PRATT & WHITNEY CANADA
SERVICE BULLETIN

P&WC S.B. No. 41020R2

TURBOSHAFT ENGINE
ELECTRONIC ENGINE CONTROL - REPROGRAMMING/REPLACEMENT OF

Summary: To meet customer requirements, introduce new Engine Electronic Control (EEC) software with improved training logic, start logic and category "A" features.

Tools Set Up
Figure 1

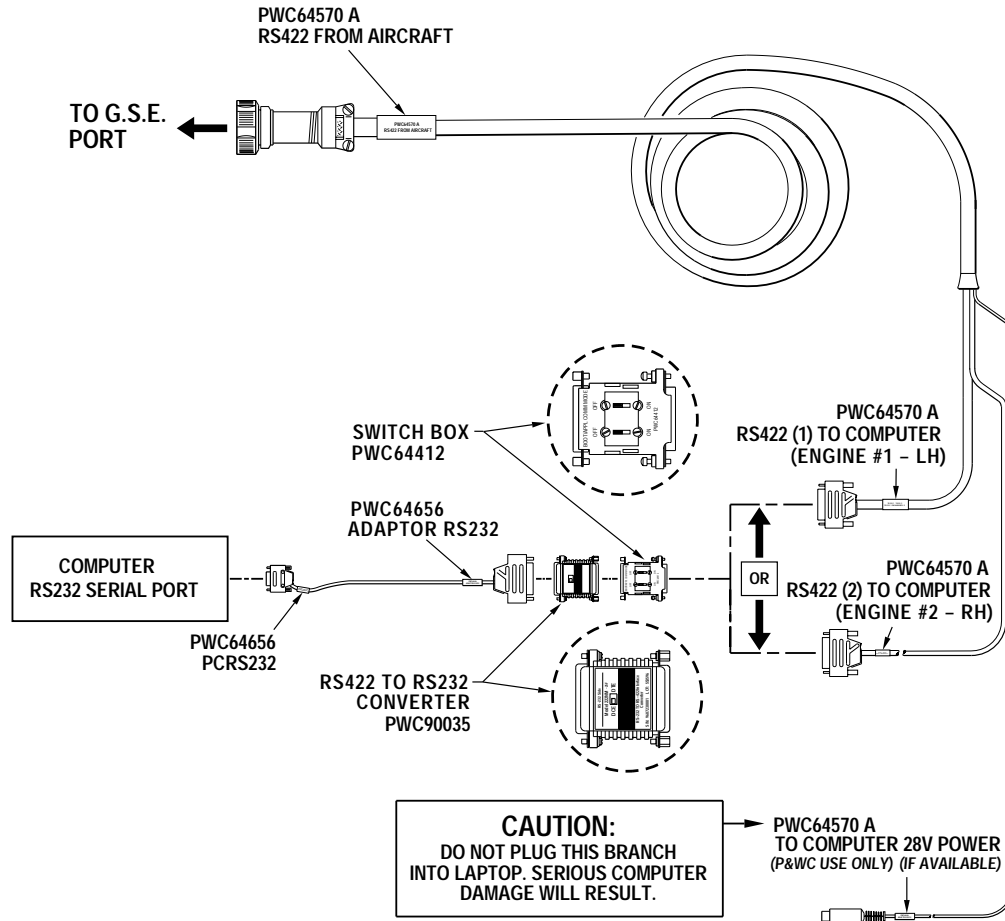
- (1) Check for normal indications on the Aircraft Instrumentation Display System per rotorcraft flight manual. If required, isolate and correct the EEC faults indications per the engine maintenance manual.
- (2) Turn the electrical power supply to the EEC to the OFF position.
- (3) Set up the tools and do all connections to the EEC and the laptop as shown (Ref. Fig. 1).

Identification Plates Location on EEC
Figure 2

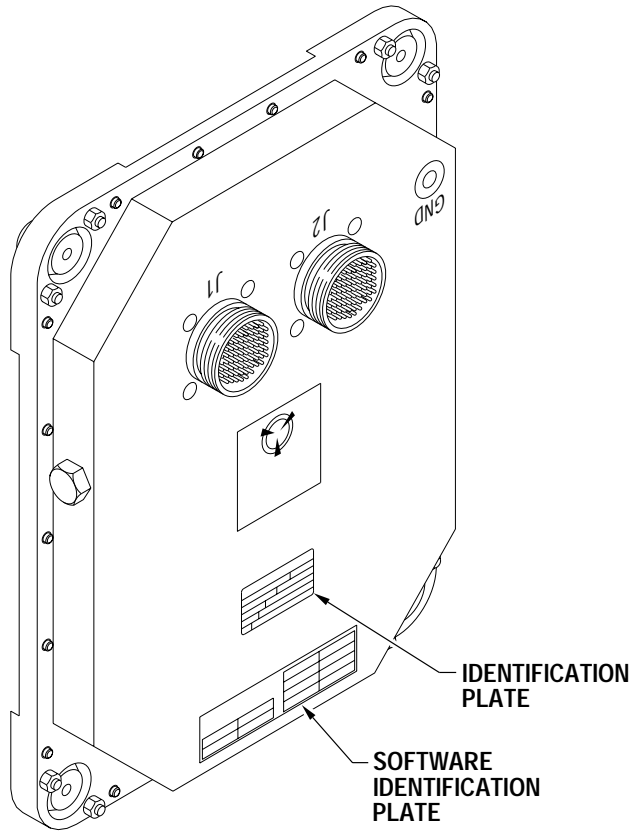
- (c) Carefully remove the old EEC identification plate.
- (d) Clean the area where the new plate will be attached (Ref. Fig. 2) with isopropyl alcohol and wipe dry with a clean, lint-free cloth. Make sure to fully remove the old adhesive.
- (e) Let the area dry thoroughly.
- (f) Remove the paper from the back of the new EEC identification plate.
- (g) Carefully position above mounting location and put the new plate in position on EEC.
- (h) Use a soft rubber roller or equivalent soft tool to apply pressure on the new plate to contact firmly with the EEC housing. Make sure there are no air bubbles caught between identification plate and EEC housing.

- (i) Proceed with step E..
- (2) If the EEC is reprogrammed in the **field** proceed as follows (Ref. Fig. 2 and Fig. 3):
